# ACCESSIBILITY ASSESSMENT

July 14, 2021

## ADA TITLE II ASSESSMENT

Housing Authority of Prince George's County - Administrative Office  
9200 Basil Court  
Largo, Maryland 20774

<b>Assembly</b>	Exterior Access Route
<b>Type</b>	Exterior Accessible Route
<b>ADA Standard</b>	403.3
<b>Barrier Detail</b>	The accessible route has cross slopes greater than 1:50 (2%).
<b>Location Description</b>	Curb Ramp CR1
<b>Observed</b>	Jun 14, 2021 by Ouraccessibleworld@gmail.com

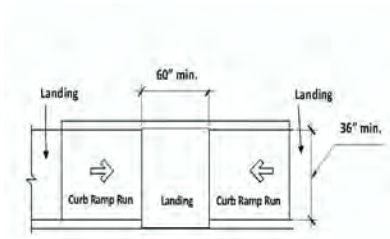
The accessible route has a cross slope of up to 9.7% for a distance of approximately 60' by 5' wide.

The walkway should be graded to a maximum 1:50 (2%) cross slope. An accessible route has maximum 1:20 (5%) running slope and maximum 1:50 (2%) cross slope. [EXCEPTION: Cross slopes not exceeding 1:48 (2.08%) are permitted.] The clear width of walking surfaces shall be 36" minimum. [EXCEPTION: The clear width shall be permitted to be reduced to 32" minimum for a length of 24" maximum provided that reduced width segments are separated by segments that are 48" long minimum and 36" wide minimum.] Where grading to maximum running slope of 1:20 (5% running slope) is not possible, provide a compliant ramped surface within the walkway with maximum slope 1:12 (8.33%) and maximum ramp run rise of 6" without handrails. If a ramped surface with running slopes greater than 1:20 (5%) and maximum 1:12 (8.33%) rises more than 6", handrails are required. The cost estimate for this barrier removal is based on grading the running slope to maximum 1:20 (5%). The quantity and order of magnitude cost estimate provided for this barrier are limited to the extent of the area identified as non-compliant. Additional costs that may be associated with removal of the barrier are not included.

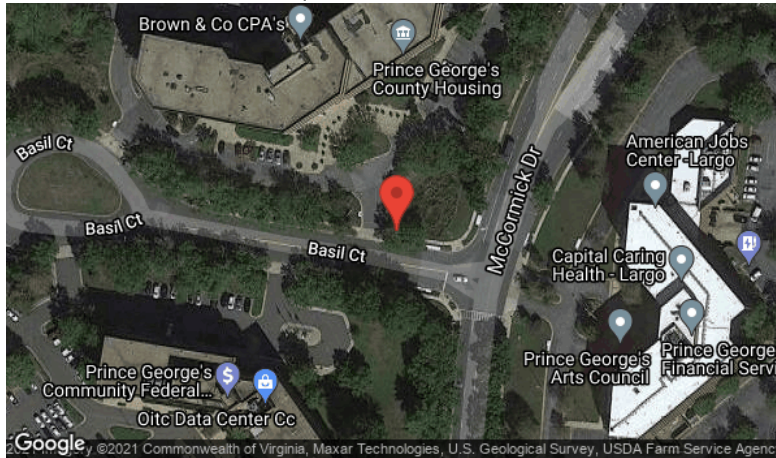
<b>Assembly</b>	Exterior Access Route
<b>Type</b>	Curb Ramp
<b>ADA Standard</b>	405.2; Table 405.2; 406; 406.2
<b>Barrier Detail</b>	The curb ramp does not meet the slope requirements.
<b>Location Description</b>	Curb Ramp CR2
<b>Observed</b>	Jun 14, 2021 by Ouraccessibleworld@gmail.com
<b>Site Conditions</b>	The curb ramp has a running slope of 10.1% and a cross slope of 5.8%.

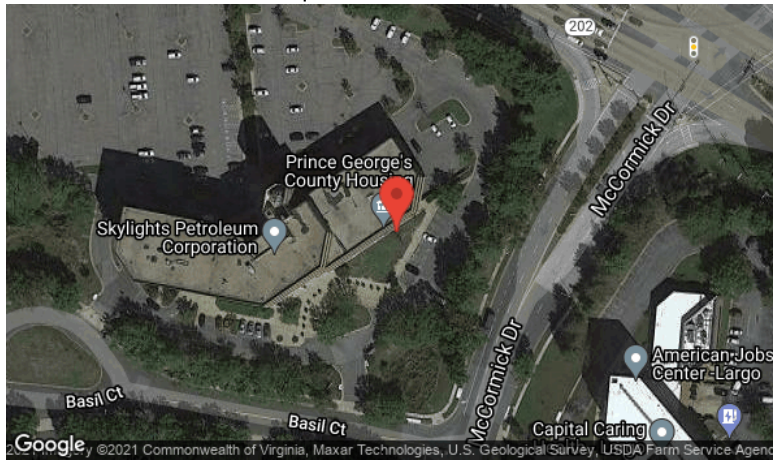
<b>Assembly</b>	Exterior Access Route
<b>Type</b>	Exterior Accessible Route
<b>ADA Standard</b>	403.3
<b>Barrier Detail</b>	The accessible route has cross slopes greater than 1:50 (2%).
<b>Location Description</b>	From Accessible Parking Spaces P1-P5 to Suite 107
<b>Observed</b>	Jun 14, 2021 by Ouraccessibleworld@gmail.com

The accessible route has cross slopes up to 2.8% for a distance of approximately 10' by 5' wide.

The walkway should be graded to a maximum 1:50 (2%) cross slope. An accessible route has maximum 1:20 (5%) running slope and maximum 1:50 (2%) cross slope. [EXCEPTION: Cross slopes not exceeding 1:48 (2.08%) are permitted.] The clear width of walking surfaces shall be 36" minimum. [EXCEPTION: The clear width shall be permitted to be reduced to 32" minimum for a length of 24" maximum provided that reduced width segments are separated by segments that are 48" long minimum and 36" wide minimum.] Where grading to maximum running slope of 1:20 (5% running slope) is not possible, provide a compliant ramped surface within the walkway with maximum slope 1:12 (8.33%) and maximum ramp run rise of 6" without handrails. If a ramped surface with running slopes greater than 1:20 (5%) and maximum 1:12 (8.33%) rises more than 6", handrails are required. The cost estimate for this barrier removal is based on grading the running slope to maximum 1:20 (5%). The quantity and order of magnitude cost estimate provided for this barrier are limited to the extent of the area identified as non-compliant. Additional costs that may be associated with removal of the barrier are not included.

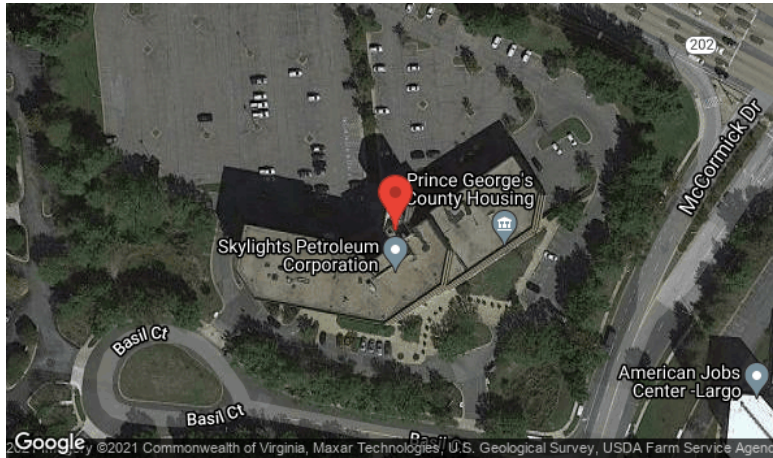
Assembly	Exterior Access Route
Type	Exterior Accessible Route
ADA Standard	302.3
Barrier Detail	The accessible route has gaps in the surface greater than 1/2" wide.
Location Description	From Accessible Parking Spaces P6 through 14 to Entrance
Observed	Jun 14, 2021 by Ouraccessibleworld@gmail.com
Site Conditions	There are gaps in the surface up to 4" wide.

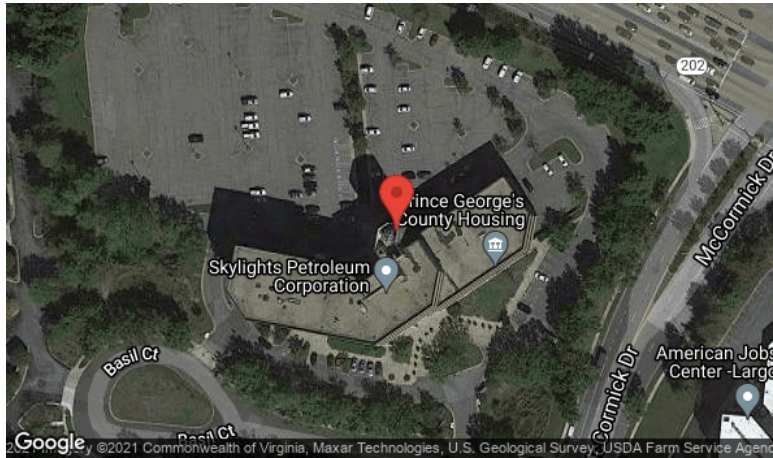
<b>Assembly</b>	Exterior Access Route
<b>Type</b>	Exterior Accessible Route
<b>ADA Standard</b>	403.3
<b>Barrier Detail</b>	The accessible route has cross slopes greater than 1:50 (2%).
<b>Location Description</b>	From Accessible Parking Spaces P6 through 14 to Entrance
<b>Observed</b>	Jun 14, 2021 by Ouraccessibleworld@gmail.com

The accessible route has a cross slope up to 2.9% for a distance of approximately 30' by 5' wide.

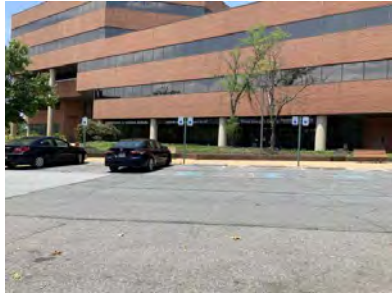
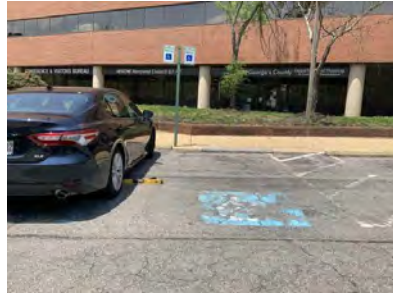
<b>Assembly</b>	Accessible Parking
<b>Type</b>	Parking Space-Car
<b>ADA Standard</b>	State of MD 05.07.D (2)(a)and (b),(3) & (6)
<b>Barrier Detail</b>	MARYLAND: Compliant signage is not provided at the space.
<b>Location Description</b>	Parking Lot 1 - Accessible Parking Spaces P1, P2, P3 and P4
<b>Observed</b>	Jun 14, 2021 by Ouraccessibleworld@gmail.com

There are 5 spaces provided. None of the accessible spaces have signage delineating the fines. One space should be designated as van accessible.

Provide mounted signage showing the International Symbol of Accessibility which is not obscured by a vehicle parked in the space, as well as a reserved parking sign and a maximum fine sign. Parking space identification signs shall include the International Symbol of Accessibility, "RESERVED PARKING" and "MAXIMUM FINE \$xxx" signs. Accessible parking fine amounts vary per county in the State of Maryland. Signs shall be 84" minimum above the stall surface measured to the bottom of the sign OR if flush to/mounted on building or wall, sign should be mounted between 72" and 120" above the stall surface. Where the sign post is mounted on a raised surface which is higher than the stall pavement, the vertical measurement shall be from the stall pavement surface to the bottom of the sign.

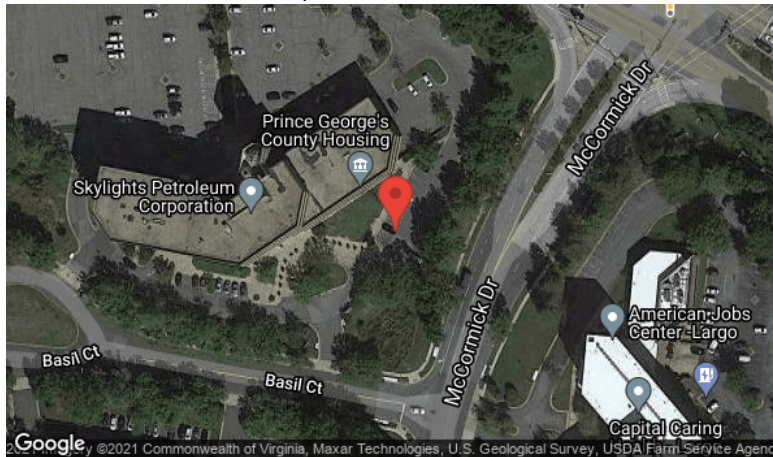
<b>Assembly</b>	Accessible Parking
<b>Type</b>	Parking Space-Van
<b>ADA Standard</b>	502.4
<b>Barrier Detail</b>	The access aisle slope is greater than 1:50 (2%).
<b>Location Description</b>	Parking Lot 1 Access Aisle at Accessible Parking Space P5
<b>Observed</b>	Jun 14, 2021 by Ouraccessibleworld@gmail.com
<b>Site Conditions</b>	The van access aisle has a running slope of up to 3.7%.

Remove and replace with an adjacent access aisle that has a slope of maximum 1:50 (2%) in all directions. [EXCEPTION: Slopes not steeper than 1:48 (2.08%) shall be permitted.] Changes in level are not permitted. Parking spaces and access aisles serving them shall be compliant. Access aisles shall be at the same level as the parking spaces they serve. Measurements shall be made to the centerline of the stripe. Where accessible stalls and aisles are not adjacent to another stall or aisle, measurements shall be permitted to include the full width of the line defining the accessible parking space or aisle. The quantity and order of magnitude cost estimate provided for this barrier are limited to the extent of the area identified as non-compliant. Additional costs that may be associated with removal of the barrier are not included.

Assembly	Accessible Parking
Type	Parking Space-Car
ADA Standard	502.4
Barrier Detail	The access aisle slope is greater than 1:50 (2%).

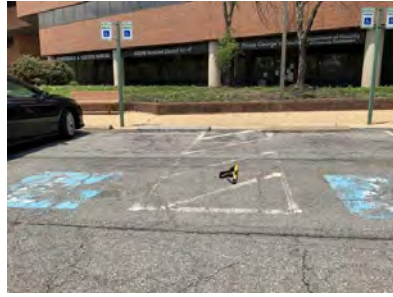
**Site Conditions** The standard access aisles have cross slopes of up to 3.4%.

Remove and replace with an adjacent access aisle that is at least 60" wide and has a slope of maximum 1:50 (2%) in all directions. [EXCEPTION: Slopes not steeper than 1:48 (2.08%) shall be permitted.] Changes in level are not permitted. Parking spaces and access aisles serving them shall be compliant. Access aisles shall be at the same level as the parking spaces they serve. Width measurements shall be made from the centerline of the markings. [EXCEPTION: Where parking spaces or access aisles are not adjacent to another parking space or access aisle, measurements shall be permitted to include the full width of the line defining the parking space or access aisle.] The quantity and order of magnitude cost estimate provided for this barrier are limited to the extent of the area identified as non-compliant. Additional costs that may be associated with removal of the barrier are not included.

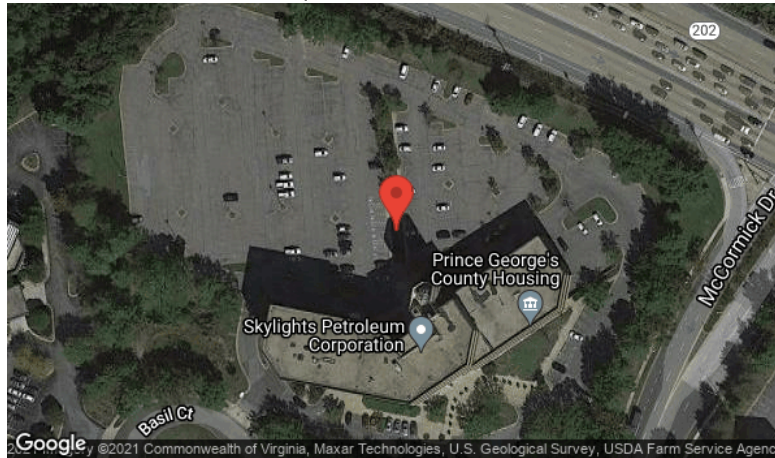
<b>Assembly</b>	Exterior Access Route
<b>Type</b>	Curb Ramp
<b>ADA Standard</b>	406.2
<b>Barrier Detail</b>	A curb ramp is not provided where the accessible route crosses a curb.
<b>Location Description</b>	Parking Lot 1 Access Aisles at Accessible Parking Spaces P6 to P14
<b>Observed</b>	Jun 14, 2021 by Ouraccessibleworld@gmail.com
<b>Site Conditions</b>	A curb ramp is not provided where the access aisles join the accessible route.

<b>Assembly</b>	Accessible Parking
<b>Type</b>	Parking Space-Van
<b>ADA Standard</b>	502.4
<b>Barrier Detail</b>	The parking space slope is greater than 1:50 (2%).
<b>Location Description</b>	Parking Lot 1 Accessible Parking Space P1-5
<b>Observed</b>	Jun 14, 2021 by Ouraccessibleworld@gmail.com

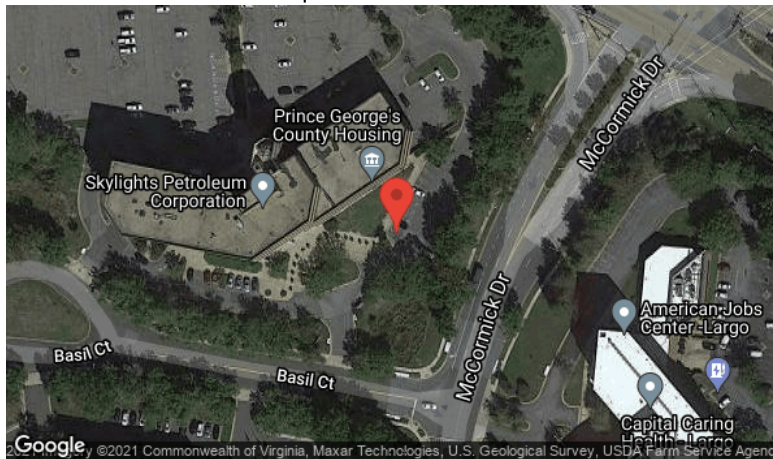
There are 5 spaces provided. Four standard and one van space. The van space has running slopes up to 2.6% and cross slopes up to 3.5%.

Remove and replace with a van space which has a slope of maximum 1:50 (2%) in all directions. [EXCEPTION: Slopes not steeper than 1:48 (2.08%) shall be permitted.] Changes in level are not permitted. Parking spaces and access aisles serving them shall be compliant. Width measurements shall be made from the centerline of the markings. [EXCEPTION: Where parking spaces or access aisles are not adjacent to another parking space or access aisle, measurements shall be permitted to include the full width of the line defining the parking space or access aisle.] The quantity and order of magnitude cost estimate provided for this barrier are limited to the extent of the area identified as non-compliant. Additional costs that may be associated with removal of the barrier are not included.

Assembly	Accessible Parking
Type	Parking Space-Car
ADA Standard	502.4
Barrier Detail	The access aisle slope is greater than 1:50 (2%).
Location Description	Parking Lot 1 Accessible Parking Space P1-5
Observed	Jun 14, 2021 by Ouraccessibleworld@gmail.com

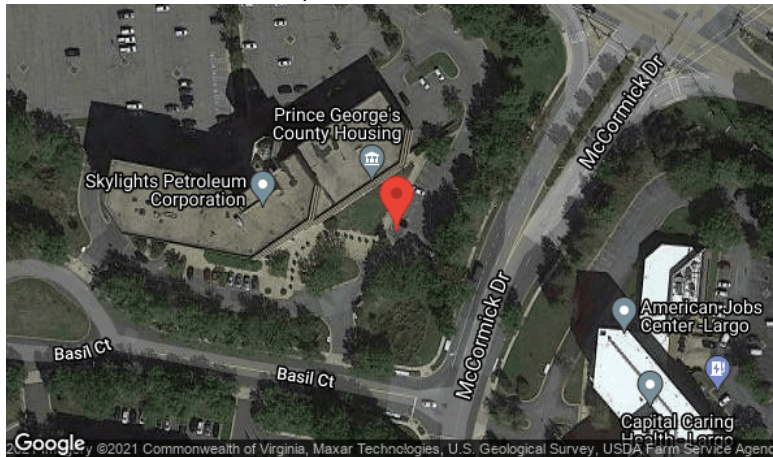
There are 4 access aisles provided. Three standard and one van. The access aisles have running slopes up to 2.6% and cross slopes up to 3.5%.

Remove and replace with an adjacent access aisle that is at least 60" wide and has a slope of maximum 1:50 (2%) in all directions. [EXCEPTION: Slopes not steeper than 1:48 (2.08%) shall be permitted.] Changes in level are not permitted. Parking spaces and access aisles serving them shall be compliant. Access aisles shall be at the same level as the parking spaces they serve. Width measurements shall be made from the centerline of the markings. [EXCEPTION: Where parking spaces or access aisles are not adjacent to another parking space or access aisle, measurements shall be permitted to include the full width of the line defining the parking space or access aisle.] The quantity and order of magnitude cost estimate provided for this barrier are limited to the extent of the area identified as non-compliant. Additional costs that may be associated with removal of the barrier are not included.

<b>Assembly</b>	Accessible Parking
<b>Type</b>	Parking Space-Van
<b>ADA Standard</b>	502.4
<b>Barrier Detail</b>	The access aisle slope is greater than 1:50 (2%).
<b>Location Description</b>	Parking Lot 1 Accessible Parking Space P1-5
<b>Observed</b>	Jun 14, 2021 by Ouraccessibleworld@gmail.com

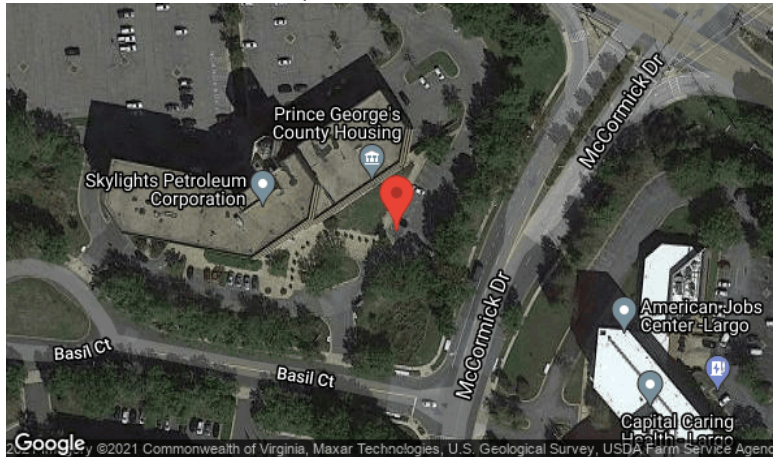
There are 4 access aisles provided. Three standard and one van. The van access aisles has running slopes up to 2.6% and cross slopes up to 3.5%.

Remove and replace with an adjacent access aisle that has a slope of maximum 1:50 (2%) in all directions. [EXCEPTION: Slopes not steeper than 1:48 (2.08%) shall be permitted.] Changes in level are not permitted. Parking spaces and access aisles serving them shall be compliant. Access aisles shall be at the same level as the parking spaces they serve. Measurements shall be made to the centerline of the stripe. Where accessible stalls and aisles are not adjacent to another stall or aisle, measurements shall be permitted to include the full width of the line defining the accessible parking space or aisle. The quantity and order of magnitude cost estimate provided for this barrier are limited to the extent of the area identified as non-compliant. Additional costs that may be associated with removal of the barrier are not included.

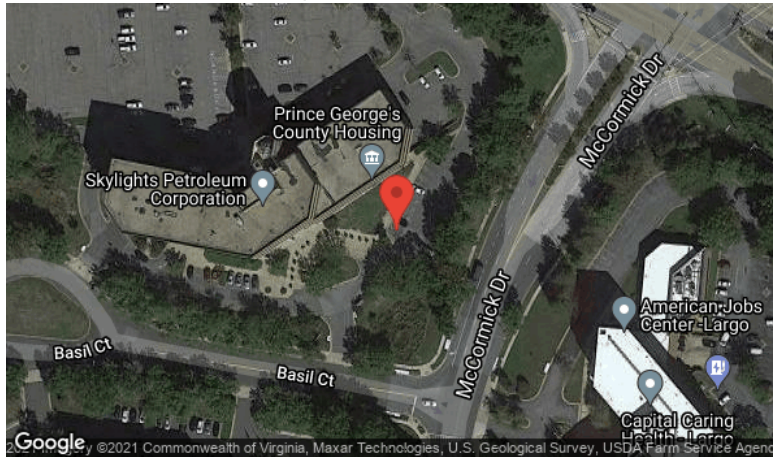
<b>Assembly</b>	Accessible Parking
<b>Type</b>	Parking Space-Van
<b>ADA Standard</b>	State of MD 05.07.D (2)(a)and (b),(3) & (6)
<b>Barrier Detail</b>	MARYLAND: Compliant signage is not provided at the space.
<b>Location Description</b>	Parking Lot 1 Accessible Parking Space P5
<b>Observed</b>	Jun 14, 2021 by Ouraccessibleworld@gmail.com

There are 5 spaces provided. None of the accessible spaces have signage delineating the fines. One space should be designated as van accessible. Accessible parking space P5 an the adjacent access aisle are compliant sizes for a van accessible parking space.

Provide a mounted sign for a van accessible stall which is not obscured by a vehicle parked in the space. Parking space identification signs shall include the International Symbol of Accessibility. Signs identifying van parking spaces shall contain the designation "van accessible," "Reserved Parking", and "Maximum Fine \$XXX". Accessible parking fine amounts vary per county in the State of Maryland. Signs shall be 84" minimum above the finish floor or ground surface measured to the bottom of the sign OR if flush to/mounted on building or wall, sign should be mounted between 72" and 120" above grade.

Assembly	Accessible Parking
Type	Parking Space-Car
ADA Standard	502.4
Barrier Detail	The slope of the parking space is greater than 1:50 (2%).
Location Description	Parking Lot 1 Accessible Parking Spaces P1-5
Observed	Jun 14, 2021 by Ouraccessibleworld@gmail.com

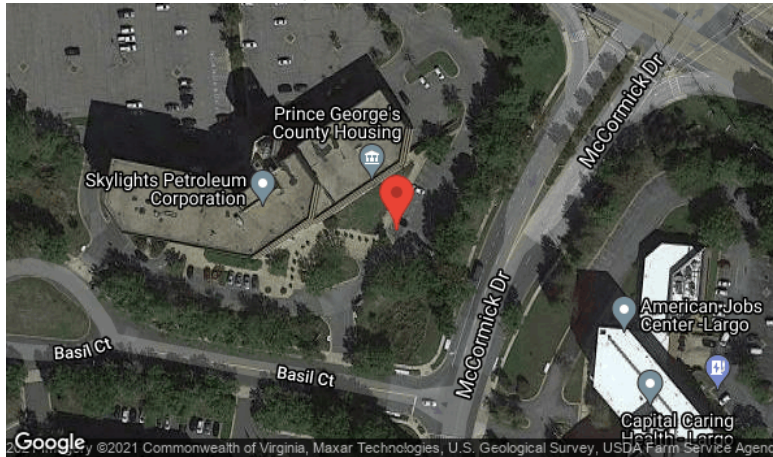
There are 5 spaces provided. Four standard and one van space. The spaces have running slopes up to 2.6% and cross slopes up to 3.5%.

Remove and replace with a parking space that has no more than 1:50 (2%) slope in all directions. [EXCEPTION: Slopes not steeper than 1:48 (2.08%) shall be permitted.] Changes in level are not permitted. Parking spaces and access aisles shall be level with surface slopes not exceeding 1:50 in all directions. Parking spaces and access aisles serving them shall be compliant. Access aisles shall be at the same level as the parking spaces they serve. The quantity and order of magnitude cost estimate provided for this barrier are limited to the extent of the area identified as non-compliant. Additional costs that may be associated with removal of the barrier are not included.

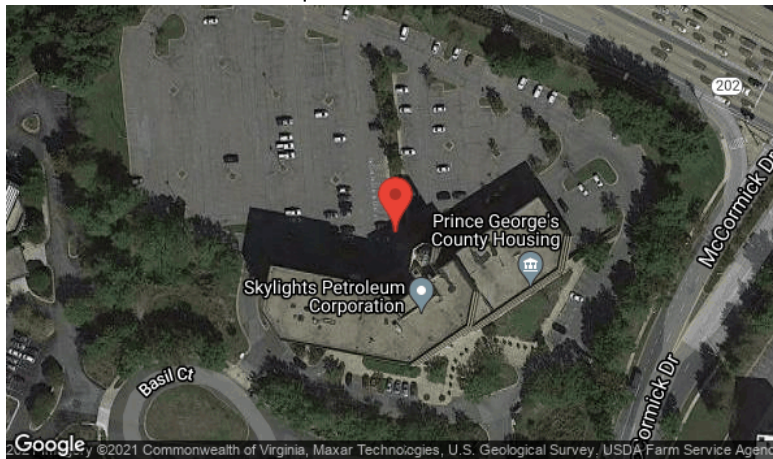
<b>Assembly</b>	Accessible Parking
<b>Type</b>	Parking Space-Van
<b>ADA Standard</b>	State of MD 05.07.D (2)(a)and (b),(3) & (6)
<b>Barrier Detail</b>	MARYLAND: Compliant signage is not provided at the space.
<b>Location Description</b>	Parking Lot 1 Accessible Parking Spaces P13 and 14
<b>Observed</b>	Jun 14, 2021 by Ouraccessibleworld@gmail.com

There are 9 spaces provided. 2 should be designated as van accessible. Spaces P13 and P14 and the access aisle between them are compliant sizes to be van accessible.

Provide a mounted sign for a van accessible stall which is not obscured by a vehicle parked in the space. Parking space identification signs shall include the International Symbol of Accessibility. Signs identifying van parking spaces shall contain the designation "van accessible," "Reserved Parking", and "Maximum Fine \$XXX". Accessible parking fine amounts vary per county in the State of Maryland. Signs shall be 84" minimum above the finish floor or ground surface measured to the bottom of the sign OR if flush to/mounted on building or wall, sign should be mounted between 72" and 120" above grade.

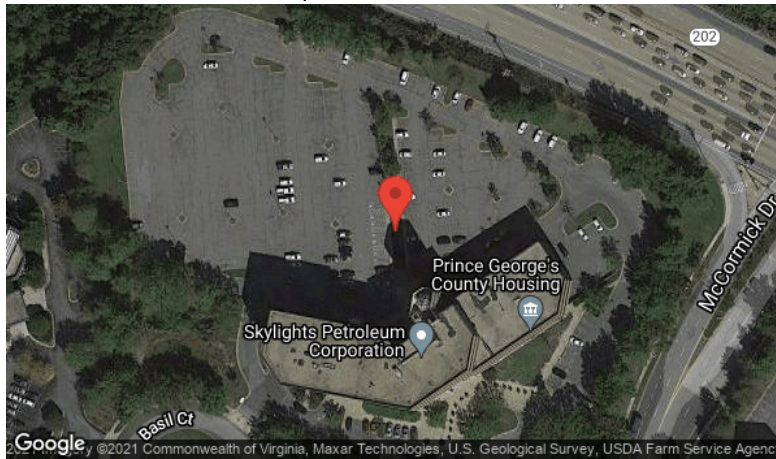
<b>Assembly</b>	Accessible Parking
<b>Type</b>	Parking Space-Car
<b>ADA Standard</b>	State of MD 05.07.D (2)(a)and (b),(3) & (6)
<b>Barrier Detail</b>	MARYLAND: Compliant signage is not provided at the space.
<b>Location Description</b>	Parking Lot 1 Accessible Parking Spaces P6, P7, P8, P9, P10, P11 and P12
<b>Observed</b>	Jun 14, 2021 by Ouraccessibleworld@gmail.com
<b>Site Conditions</b>	The signage does not contain the fine information.

Provide mounted signage showing the International Symbol of Accessibility which is not obscured by a vehicle parked in the space, as well as a reserved parking sign and a maximum fine sign. Parking space identification signs shall include the International Symbol of Accessibility, "RESERVED PARKING" and "MAXIMUM FINE \$xxx" signs. Accessible parking fine amounts vary per county in the State of Maryland. Signs shall be 84" minimum above the stall surface measured to the bottom of the sign OR if flush to/mounted on building or wall, sign should be mounted between 72" and 120" above the stall surface. Where the sign post is mounted on a raised surface which is higher than the stall pavement, the vertical measurement shall be from the stall pavement surface to the bottom of the sign.

Assembly	Exterior Access Route
Type	Exterior Accessible Route
ADA Standard	302.3
Barrier Detail	The accessible route has gaps in the surface greater than 1/2" wide.
Location Description	Sidewalk from Curb Ramp CR1 to Main Entrance
Observed	Jun 14, 2021 by Ouraccessibleworld@gmail.com

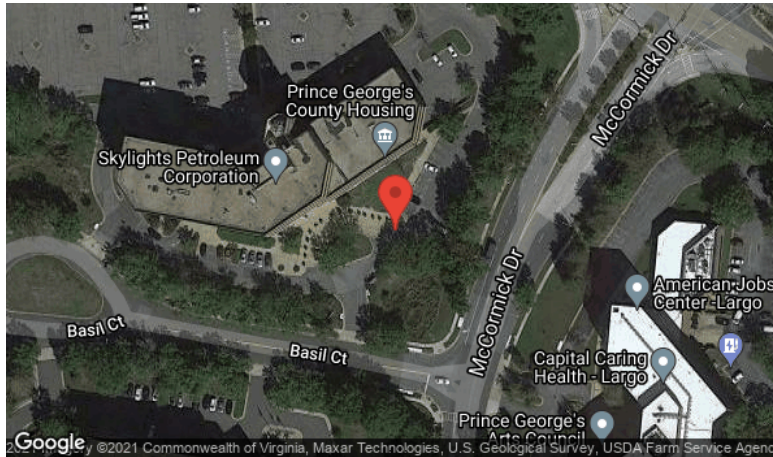
There are gaps in the accessible route of up to 5" for an area of approximately 4 square feet.

Assembly	Exterior Access Route
Type	Exterior Accessible Route
ADA Standard	403.3
Barrier Detail	The accessible route has cross slopes greater than 1:50 (2%).
Location Description	Sidewalk from Curb Ramp CR1 to Main Entrance
Observed	Jun 14, 2021 by Ouraccessibleworld@gmail.com

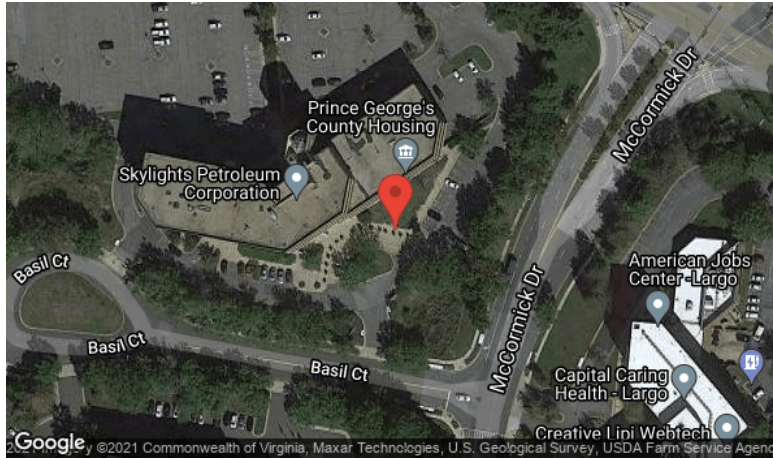
The accessible route has a cross slope of up to 5.3% for a distance of approximately 50' by 5' wide.

The walkway should be graded to a maximum 1:50 (2%) cross slope. An accessible route has maximum 1:20 (5%) running slope and maximum 1:50 (2%) cross slope. [EXCEPTION: Cross slopes not exceeding 1:48 (2.08%) are permitted.] The clear width of walking surfaces shall be 36" minimum. [EXCEPTION: The clear width shall be permitted to be reduced to 32" minimum for a length of 24" maximum provided that reduced width segments are separated by segments that are 48" long minimum and 36" wide minimum.] Where grading to maximum running slope of 1:20 (5% running slope) is not possible, provide a compliant ramped surface within the walkway with maximum slope 1:12 (8.33%) and maximum ramp run rise of 6" without handrails. If a ramped surface with running slopes greater than 1:20 (5%) and maximum 1:12 (8.33%) rises more than 6", handrails are required. The cost estimate for this barrier removal is based on grading the running slope to maximum 1:20 (5%). The quantity and order of magnitude cost estimate provided for this barrier are limited to the extent of the area identified as non-compliant. Additional costs that may be associated with removal of the barrier are not included.

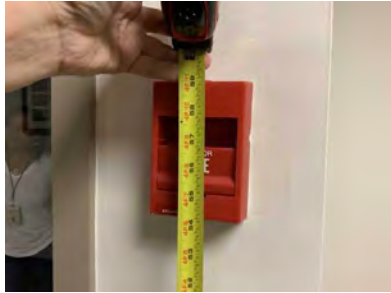
<b>Assembly</b>	Interior Access Route
<b>Type</b>	Controls And Dispensers
<b>ADA Standard</b>	308
<b>Barrier Detail</b>	The height of controls throughout the common area are not compliant.
<b>Location Description</b>	3rd Floor Breakroom
<b>Observed</b>	Jun 14, 2021 by Ouraccessibleworld@gmail.com
<b>Site Conditions</b>	The fire alarm pull is mounted at 57" above the floor.

Remove and lower the element to a compliant reach range. Where a forward reach is unobstructed, the high forward reach shall be 48" maximum and the low forward reach shall be 15" minimum above the finish floor or ground. Where a high forward reach is over an obstruction, the clear floor space shall extend beneath the element for a distance not less than the required reach depth over the obstruction. The high forward reach shall be 48" maximum where the reach depth is 20" maximum. Where the reach depth exceeds 20", the high forward reach shall be 44" maximum and the reach depth shall be 25" maximum. Where a clear floor or ground space allows a parallel approach to an element and the side reach is unobstructed, the high side reach shall be 48" maximum and the low side reach shall be 15" minimum above the finish floor or ground. [EXCEPTIONS: 1. An obstruction shall be permitted between the clear floor or ground space and the element where the depth of the obstruction is 10" maximum.] Where a clear floor or ground space allows a parallel approach to an element and the high side reach is over an obstruction, the height of the obstruction shall be 34" maximum and the depth of the obstruction shall be 24" maximum. The high side reach shall be 48" maximum for a reach depth of 10" maximum. Where the reach depth exceeds 10", the high side reach shall be 46" maximum for a reach depth of 24" maximum.
